Access Compliance Report Public Rights-of-Way (Curb Ramps)

Main Street: PERCHERON_DR		Cross Street: N/A		Location:	S
ADA ID: RPRK211112145105	Ramp Type: Type 4 - Parallel	Initial Pass/Fail: Fail	Overall Compliance: No	Severity Score:	2
Codes/Mitigation Info/Possible Solution			Field Measurements/Component Compliance

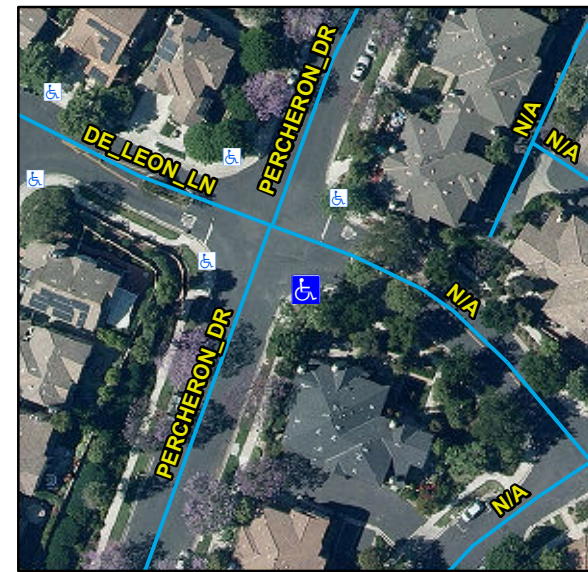
R204.3, R304.5.3, STD 1115

Compliance	Description	Data	Compliance	Description	Data
N/A	Ramp Length LT (in)	132	N/A	Ramp Length RT (in)	127
Yes	Ramp Width LT (in)	53	Yes	Ramp Width RT (in)	53
Yes	Ramp Run Slope LT (%)	3.3	Yes	Ramp Run Slope RT (%)	5
No	Ramp Cross Slope LT (%)	3.8	Yes	Ramp Cross Slope RT (%)	1.7
N/A	Landing Present	N/A	N/A	DWS Provided	N/A
N/A	Landing Length (in)	N/A	N/A	DWS Contrast	N/A
N/A	Landing Width (in)	N/A	N/A	DWS Length (in)	N/A
N/A	Landing Run Slope (%)	N/A	N/A	DWS Full Width	N/A
N/A	Landing Cross Slope (%)	N/A		DWS Offset Type	N/A
N/A	Landing Movement Obstructed?	N/A	N/A	DWS Offset Left (in)	N/A
	Landing Movement Type	N/A	N/A	DWS Offset Right (in)	N/A
N/A	Landing Shared	N/A			
N/A	Clear Space	Yes			
N/A	Clear Space To Crosswalk (in)	N/A			
N/A	Marked Crosswalk 1	No	N/A	Marked Crosswalk 2	No
	Crossing 1 Direction	NE		Crossing 2 Direction	NW
	Marked Crosswalk 1 Width (in)	N/A		Marked Crosswalk 2 Width (in)	N/A

Remove & Replace Curb Ramp With Two New Directional Ramps or Equivalent.
